Technical Service Bulletin

Transaction No.: **2082553/1**

90 Panoramic display: noises in area of panoramic display, noises between panoramic display and background light module

Figure 1. Attaching a piece of felt (example image).

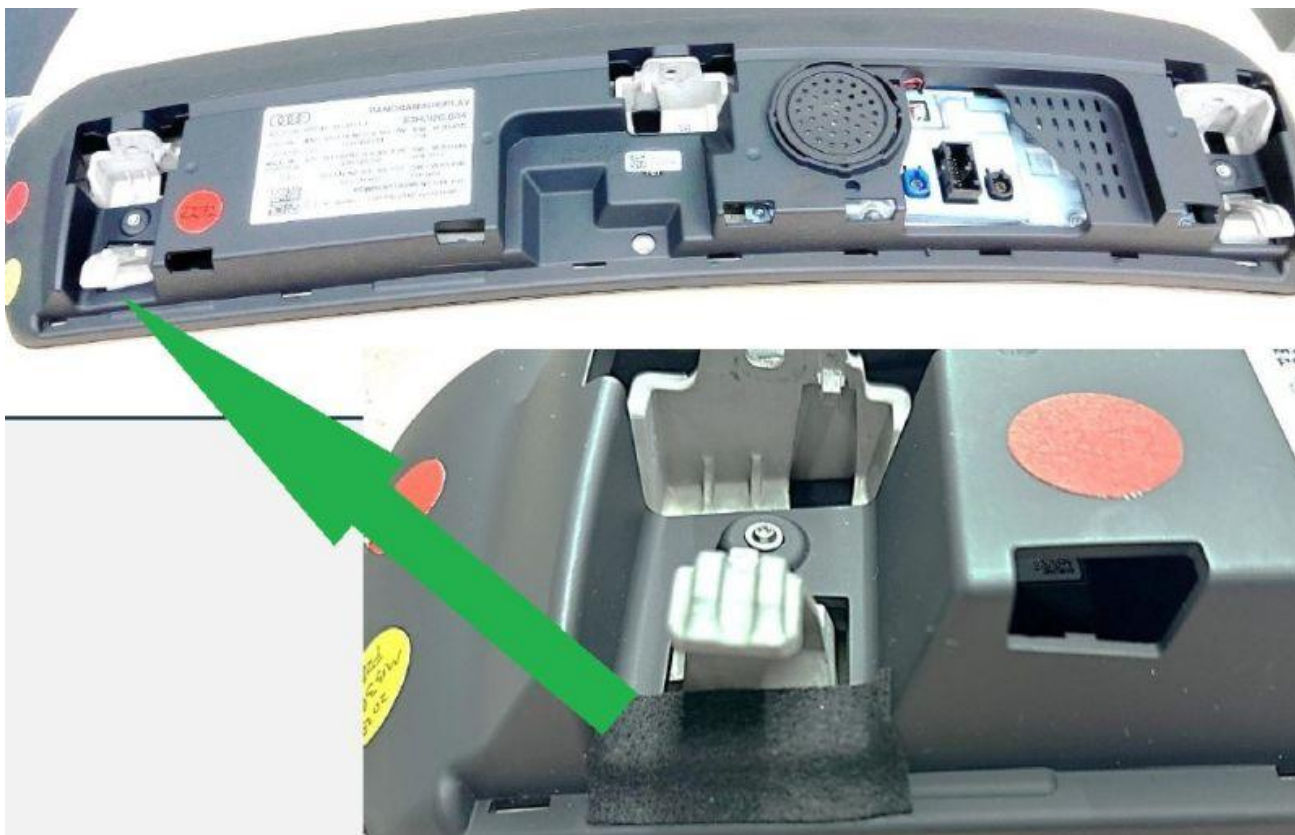
Noises can be traced to the area between the panoramic display and the background lighting module under the panoramic display.

Noises between panoramic display and background lighting module on vehicles fitted with the optional **background lighting package**.

Please attach a piece of **felt** (part number **443 857 991 Q**) in the area indicated by a green arrow in the image.
